Subject: DAP Emissions Information
North MAP/DAP Plant
Farmland Hydro, L.P.
DEP File No. 1050053-020-AC, PSD-FL-246

Subject: Additional Information
 North MAP/DAP Plant
 Farmland Hydro, L.P.
 DEP File No. 1050053-020-AC, PSD-FL-246

Subject: Additional Information
North MAP/DAP Plant
Farmland Hydro, L.P.
DEP File No. 1050053-020-AC, PSD-FL-246.

**Technical Review of Prevention of Significant Deterioration
Permit Application for Farmland Hydro, L.P.'s
Proposed Increase in Production of Monoammonium Phosphate
and Diammonium Phosphate
Polk County, Florida**

ATTACHMENT 1
PROCESS FLOW DIAGRAM

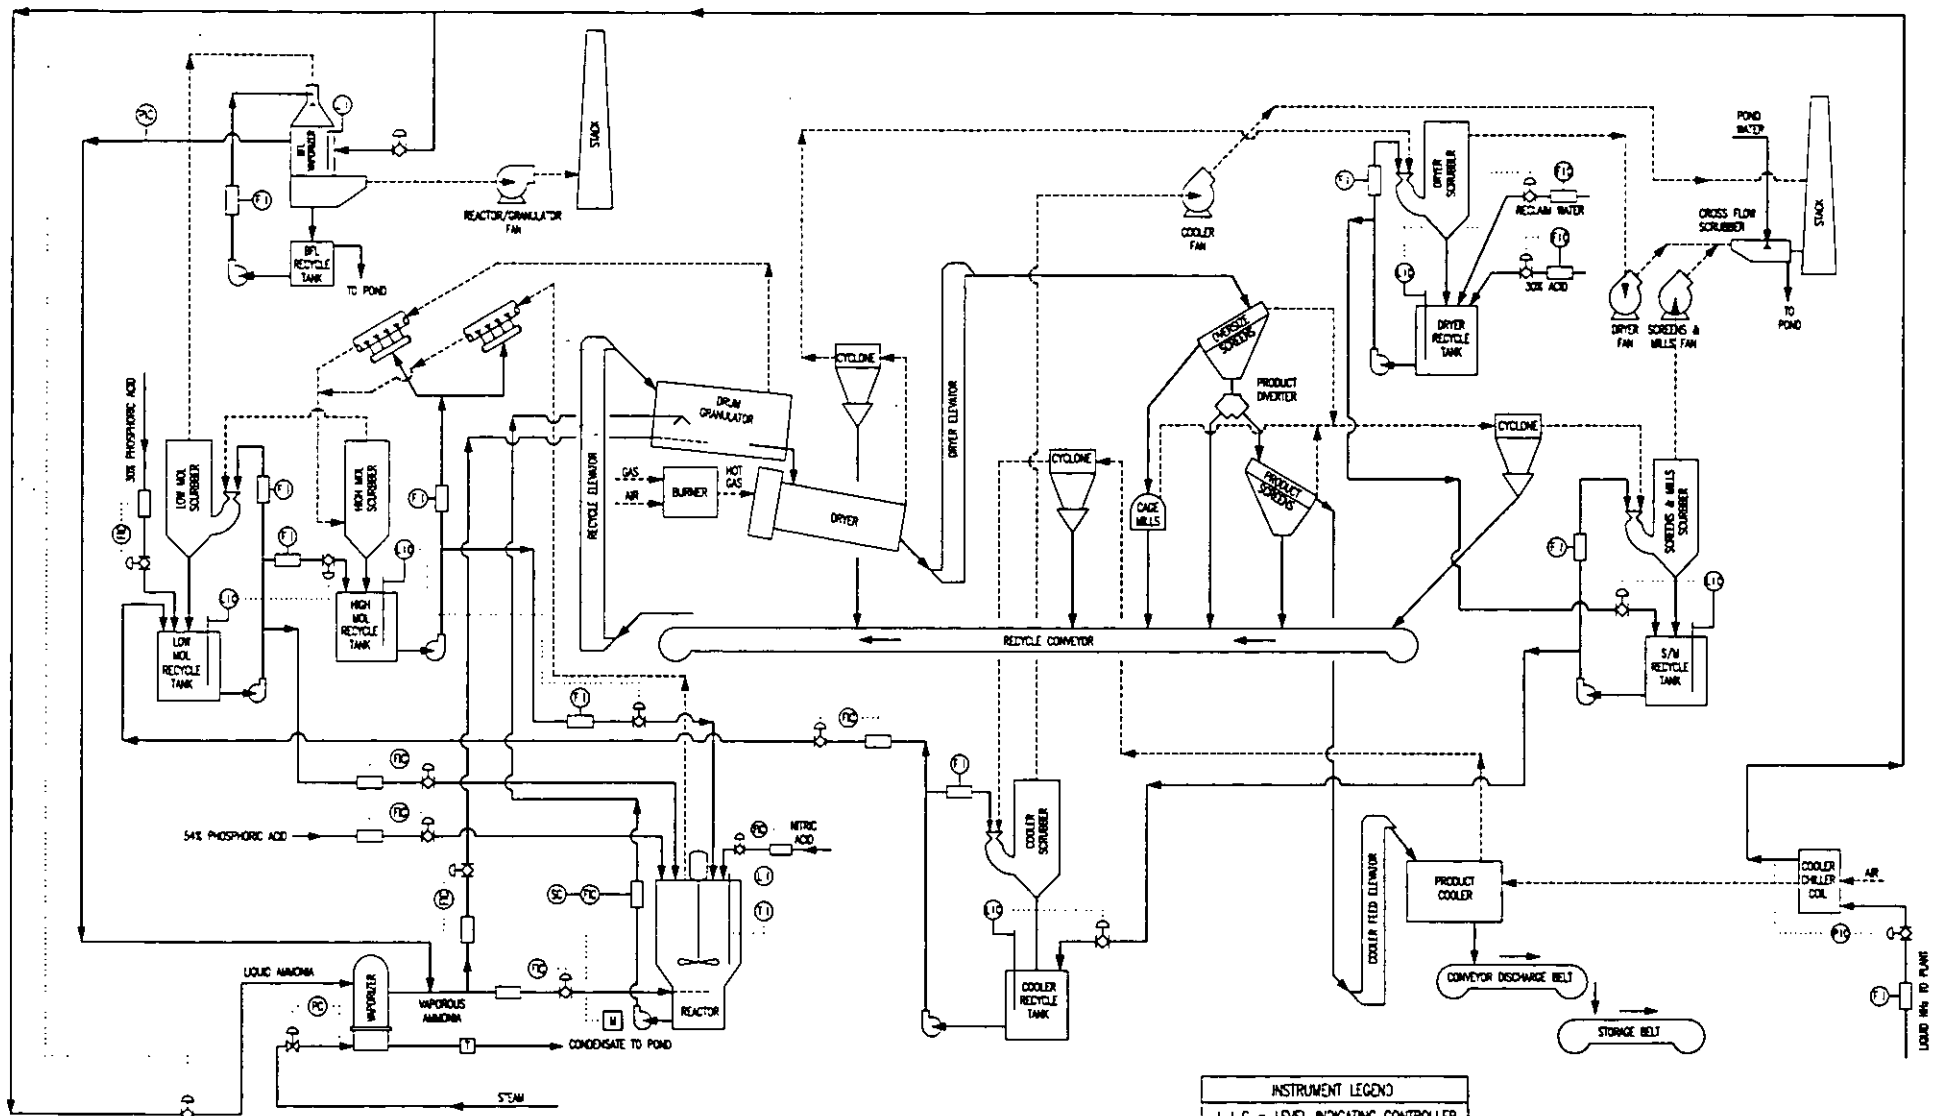
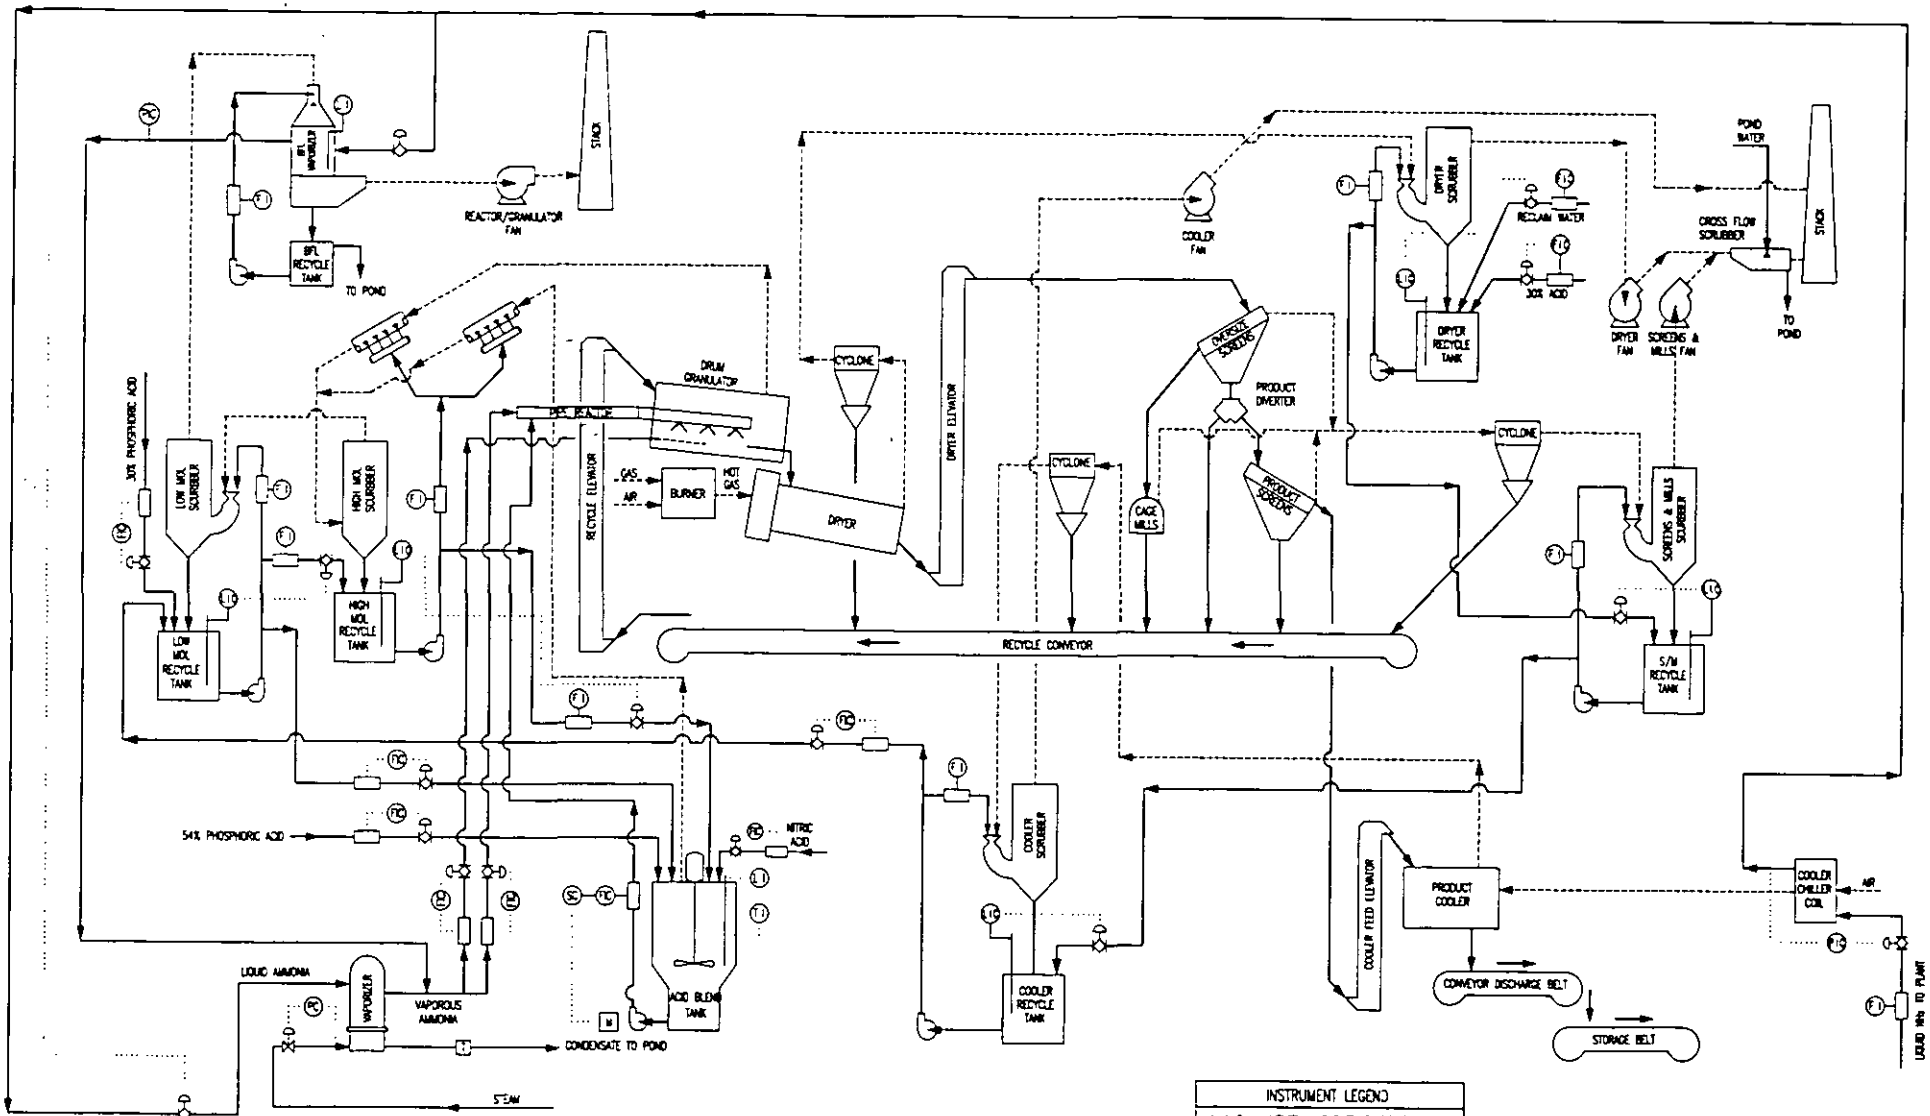
1. Please provide the process flow diagram for this project indicating the scrubbers at each process step and any minor modifications required to facilitate the increase in production rates for MAP/DAP. Also, provide information on the scrubbers, what type, efficiencies, etc.

The proposed project does not involve any planned changes in the plant equipment. Some minor changes may be made, if required, to pumps, piping, ducting, etc. The requested information is presented in Attachment 1.

PLEASE SEE ATTACHED SCRUBBER PROCESS FLOW DIAGRAM FOR OVERALL ARRANGEMENT.
